Access Compliance Report Public Rights-of-Way (Curb Ramps)

Main Street: TERRACE_RD Cross Street: ANTONIO_PKWY Location: SE

ADA ID: RPRK211115164834 Ramp Type: Type 1 - Perpendicular Diagonal Initial Pass/Fail: Pass Overall Compliance: No Severity Score: 16

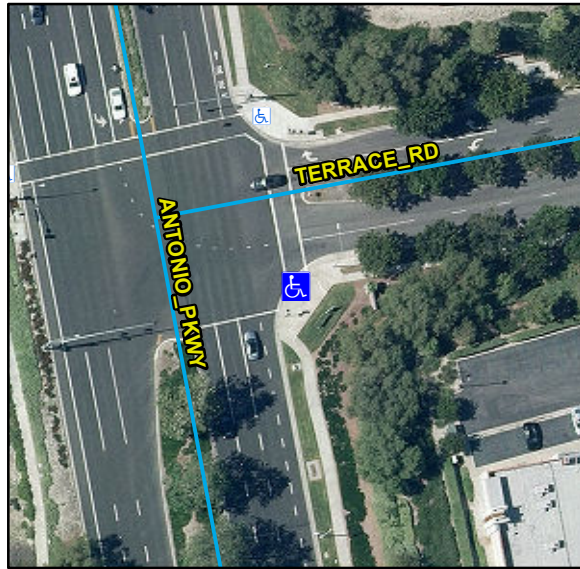
R304.2.2, R304.2.2-Perp, R304.3.2-Para, R304.5.3, R305, R304.5.4, STD 1115

Remove & Replace Curb Ramp With Two New Directional Ramps or Equivalent. Remove & Replace Gutter.
